Project	IEEE 802.16 Broadband Wireless Access Working Group < http://ieee802.org/16 >	
Title	Problem in Interleaver and Permutation Combination in OFDMA	
Date Submitted	2005-07-13	
Source(s)	Ayelet Doron Yuval Lomnitz Uri Perlmutter Eyal Bick Dov Andelman Assi Jakoby Alexei Davydov Weisman Tzahi Intel.	Ayelet.Doron@intel.com Yuval.Lomnitz@intel.com Uri.PerlMutter@intel.com Eyal.Bick@intel.com Dov.Andelman@intel.com Assi.Jakoby@intel.com Alexei.Davydov@intel.com Tzahi.Weisman@intel.com
Re:	IEEE P802.16-2004/Cor1-D3	
Abstract	Correct the misfortunate combination of interleaver and permutation	
Purpose	Adopt changes	
Notice	This document has been prepared to assist IEEE 802.16. It is offered as a basis for discussion and is not binding on the contributing individual(s) or organization(s). The material in this document is subject to change in form and content after further study. The contributor(s) reserve(s) the right to add, amend or withdraw material contained herein.

Problem in Interleaver and Permutation Combination in OFDMA

Figure 1: Worst case scenario of permutation-interleaver combination

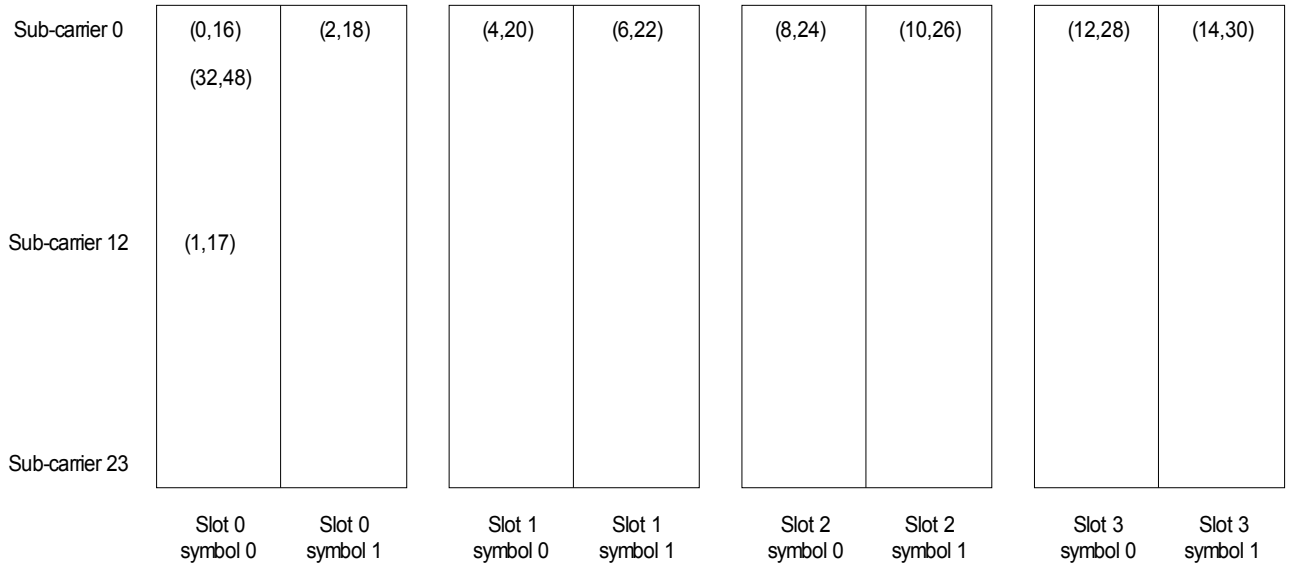
The interleaver definition with $d=16$ might cause a performance degradation in some cases, due to a disastrous combination of interleaving and permutation. This is because, in OFDMA, the permutation actually performs an “interleaving like” operation, which partially reverse the current interleaver operation. This performance degradation occurs with burst allocations having low frequency diversity, for example bursts allocated to a single sub-channel. In these cases, adjacent coded bits might be transmitted on the same sub-carrier. Thus the interleaver operation becomes useless.

With the current interleaver dimension $d = 16$, for a worst case scenario (DL PUSC, burst allocation of 1 sub-channel, 4 slots in a FEC block, QPSK constellation) this period can be as small as 2 bits!! This example is depicted in Figure 1 where the numbers in brackets are the indices of the coded bits before the interleaver.

Thus, we propose to add an optional interleaving scheme to the CC- TB to allow equal (better) performance to all burst allocations.

Figure 2: Example of correlation in slot and FEC block

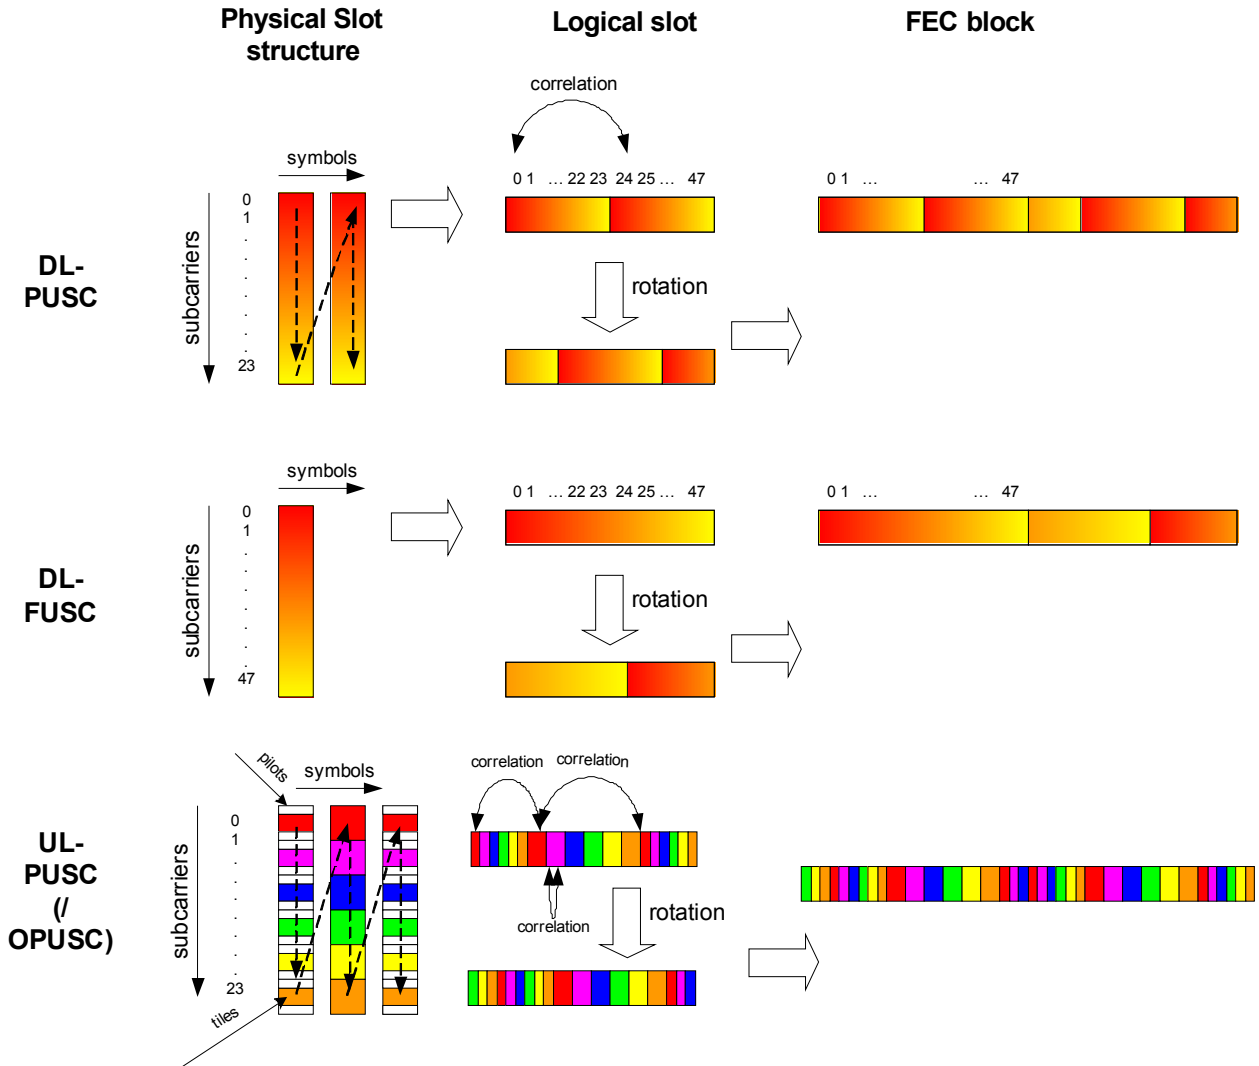
The reason for this is that the order of subcarriers passed to the de-interleaver (in the receive side) is not a linear frequency-domain order (which the interleaver was designed for), but an arbitrary order. This order depends on the permutation, on the way the 48 logical subcarriers are mapped to physical subcarriers, on the in-slot rotation between subchannels, and on the way the slots are aggregated. The following figure shows the correlation structure in a FEC block on which the de-interleaver works (and of which the interleaver is unaware):

The seemingly "random" structures of correlations in the FEC block are processed by the de-interleaver and create another "seemingly random" correlation structure at the input to the decoder. However, since these sequences are repetitive and not random, there are unfortunate choices of FEC block size for each permutation that create high correlations and reduce the performance significantly.
